From: Michael Bourke
Sent: 5/12/2023 9:30:59 PM
To: Council Northernbeaches Mailbox
Subject: TRIMMED: Objection to Application Number: DA2023/1395
Attachments: Application Number 2023 1395 Objection 5 Dec 23.pdf;

Objection to Application Number: DA2023/1395

The purpose of this letter is to object against the proposed development **Application Number: DA2023/1395** at 1010-1014 Pittwater Road, Collaroy.

Figure 2: Additional massing beyond that of No. 1000-1008 Pittwater Rd shown hatched in red

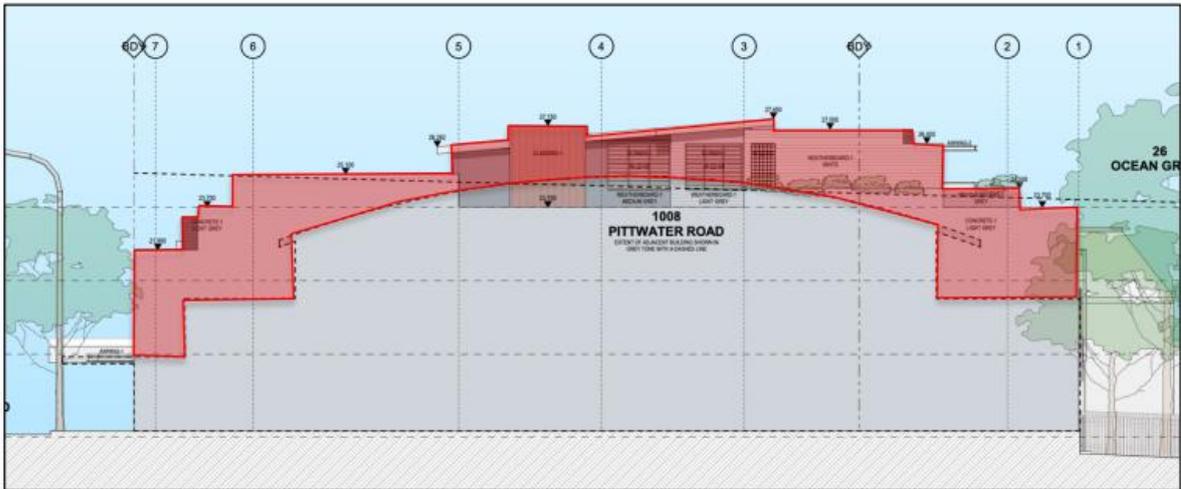
In relation to the height of the development. The Cl 4.6 argues that the proposed height is compatible with the height of the adjoining building at No 1000-1008 Pittwater Road. Yet the proposed development plans indicate a ridge height, 2.45m higher than No. 1000-1008 Pittwater Road.¹ Moreover, the development at No. 1000-1008 Pittwater Rd allows for larger setbacks or more of a stepped form to minimise massing. The proposed development allows for a massing far beyond that of No 1000- 1008 Pittwater Rd, as indicated in Figure 2. Accordingly, the proposed development is not a contextually responsive design, as they have indicated in C1.46 to justify the building height variation.

¹ The proposed development has a ridge height of RL27.459 in comparison to No. 1000-1008 Pittwater Roads maximum ridge height of RL25.009.

Figure 3: Extract from Architectural plans Section A

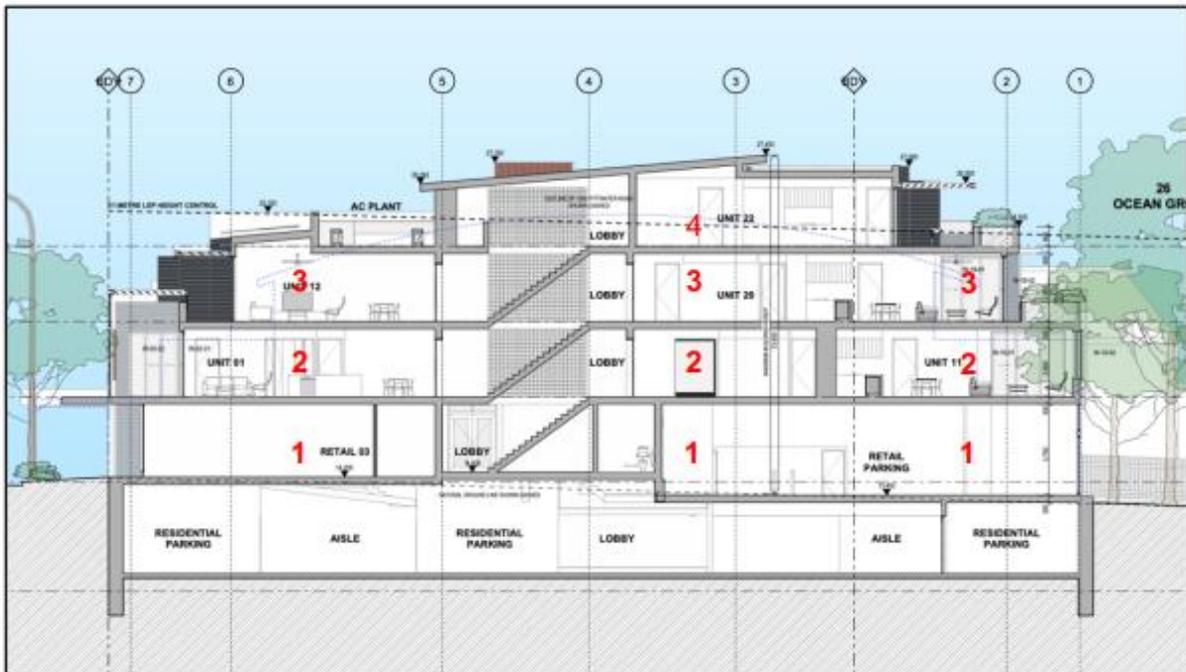
The controls require a maximum of 3 storeys within the 11m height control, with the 3rd storey / top floor substantially reduced in order to reduce visual bulk. The proposal is contrary to this requirement adding an additional level, located within the centre of the site as outlined in Figure 3, with the proposed 3rd storey occupying the entire footprint. Although the 4th storey is setback substantially from Pittwater Road the transition in scale to the adjacent residential development within Cliff Road and our property is inadequate.

This design will materially impact our family's ability to enjoy our own backyard due to the overshadowing and visual bulk. The proposed development fails to be consistent with the established scale and pattern of development along the East side of Pittwater Road. Additionally, the 4th storey fails to increase amenity of the building.

Figure 4: Visible Massing

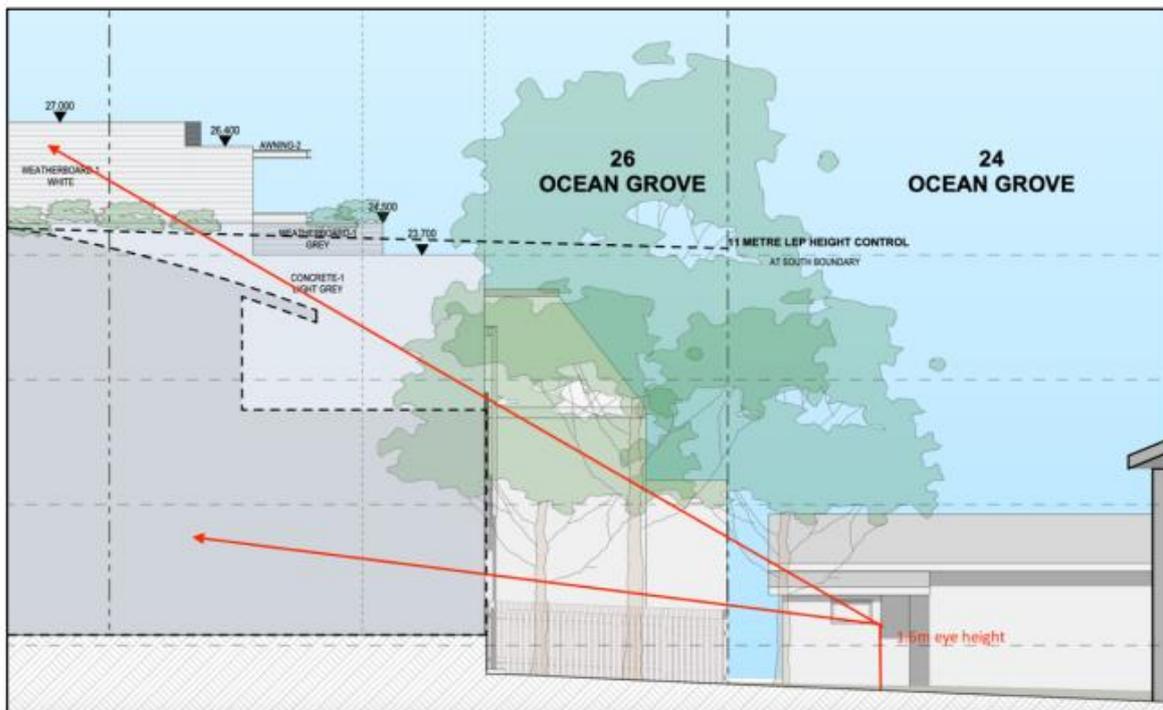
Holly and I have strong issue with the privacy impact, as a result of the top storey (Level 3), which does not comply with the 11m height requirements/guidelines/provisions. A simple line drawing (please refer to Figure 4) demonstrates the impact of the non-compliant aspects of the plan that lead to additional massing and overshadowing to our single level home at 24 Ocean Grove that would not be reasonably anticipated with a compliant development.
